## **PEAKE PLACE SUBDIVISION, RESUBDIVISION OF**

APPLICATION NUMBER 5 DATE June 15, 2006  
APPLICANT Peake Place Subdivision, Resubdivision of  
REQUEST Subdivision

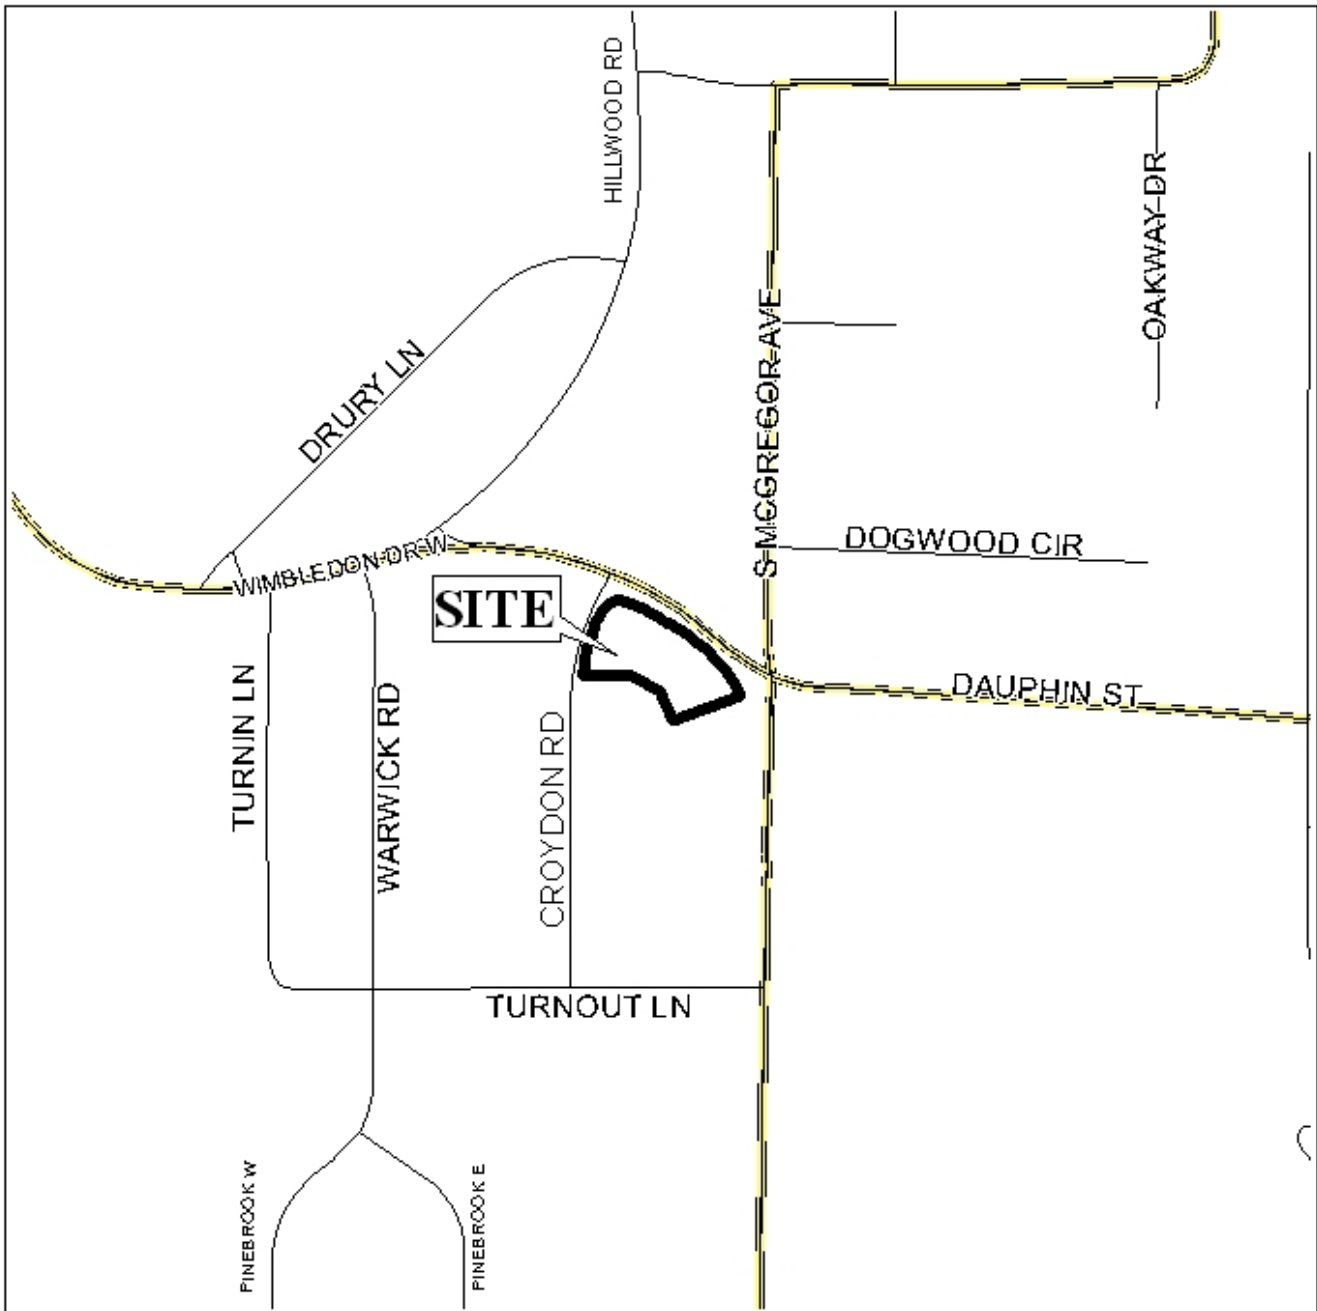
The plat illustrates the proposed 1.1± acre, four-lot subdivision, which is located on the South side of Wimbledon Drive East, extending from South McGregor Avenue to Croydon Road, and is in Council District 5. The applicant indicates that the site is served by public water and sanitary sewer; however, based on MAWSS comments above, the applicant should submit proof that each lot will be served by public water and sanitary sewer, prior to signing the final plat. This is due to recent changes in State regulations, which require public water *and* sanitary sewer service for lots with 15,000 square feet or less.

The purpose of the application is to create four lots from five existing lots of record.

The site fronts Wimbledon Drive, a planned major street with an 80-foot right-of-way, and Croydon Road, which has a 60-foot right-of-way.

Access management is a concern along this major street. The previous approval, for a five-lot subdivision, denied Lot 1 access to Wimbledon Drive; and limited the remaining four lots to two shared driveways. The previous review found that the traffic volumes along Wimbledon Drive merited the provision of a 20-foot ingress and egress easement at the rear of the lots, as an alternative to traveling along the major street; this finding is reaffirmed. The previous review also limited the site to two shared driveways along Wimbledon Drive; this condition should remain.

The plat meets the minimum requirements of the Subdivision Regulations and is recommended for Tentative Approval, subject to the following condition: 1) submission of proof that each lot will be served by public water and sanitary sewer, prior to signing the final plat; 2) the placement of a note on the final plat stating that the site is limited to a total of two curb cuts to Wimbledon Drive, and a single alley-way access to Croydon Road, with size, location, and design of all curb cuts to be coordinated with Traffic Engineering.
